MIL-G-50681D (AR)
AMENDMENT 1
24 June 1991

MILITARY SPECIFICATION

GATE CIRCUIT, MULTIPLE, BOARD ASSEMBLY - LOWER: 10548550

FIGURE 5. Board Assembly - lower test setup.

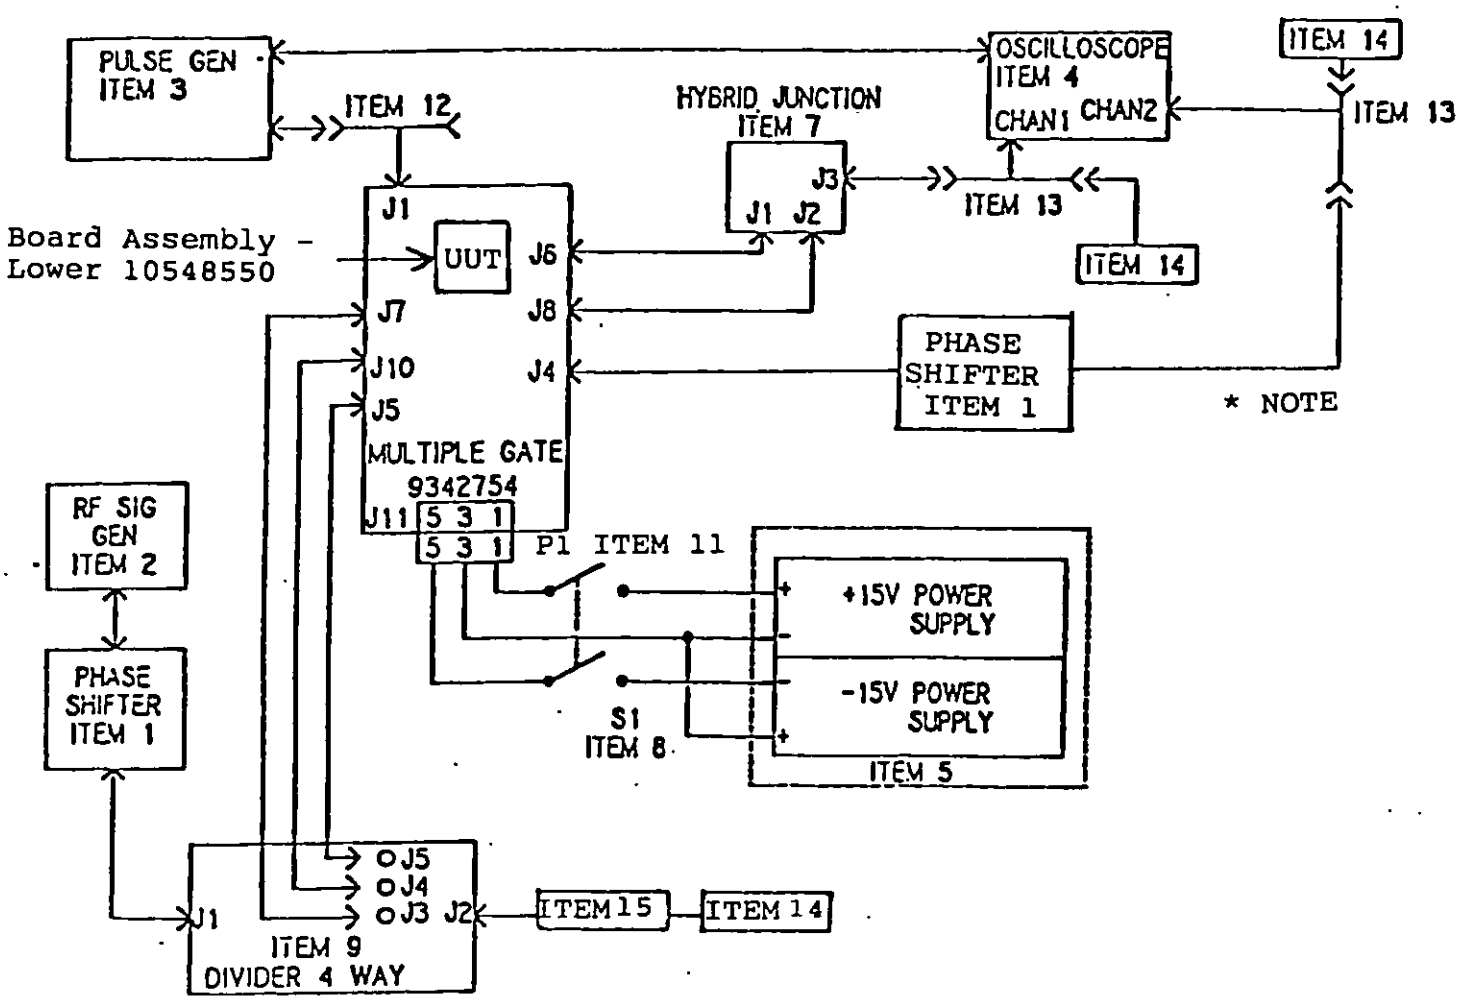
Add Figure 5. enclosed (page 6A).

Adjust Channel 2 Cable length as necessary to place Channel 1/ Channel 2 Waveform relationship into Phase Shifter ADjustment Range.

"3.5.2.3.4 Gate Noise. With the board assembly-lower connected with the test setup as shown in Figure 5, a 60± 1% MHz signal and a monitored 2.8 V p-p signal per gate applied to J5, J7 and J10 of the unit under test, the amplitude of the algebraic sum of the Early Gate and Sum Gate signals during the Early Gate period shall be less than 1.0 V p-p. The amplitude of the algebraic sum of the Late Gate and inverted Sum Gate signals during the Late Gate period shall be less than 1.0 V p-p."

"4.7.3.4.4 Gate noise. Connect the unit under test to the test setup per Figure 5. Adjust channel 2 Phase Shifter so that the Early Gate on channel 1 is 180° out of phase with the Sum Gate on channel 2. Adjust variable gain on channel 2 for equal amplitude waveforms on channels 1 and 2. Place oscilloscope in channel 1 and 2 algebraic add function and readjust channel 2 phase shifter for Early Gate null. Resultant waveforms in the Early Gate shall be less than 1.0 V p-p. Place oscilloscope channel 2 in invert mode. Readjust amplitude and phase for Late Gate null. Resultant waveforms in the Late Gate shall be less than 1.0 V p-p."
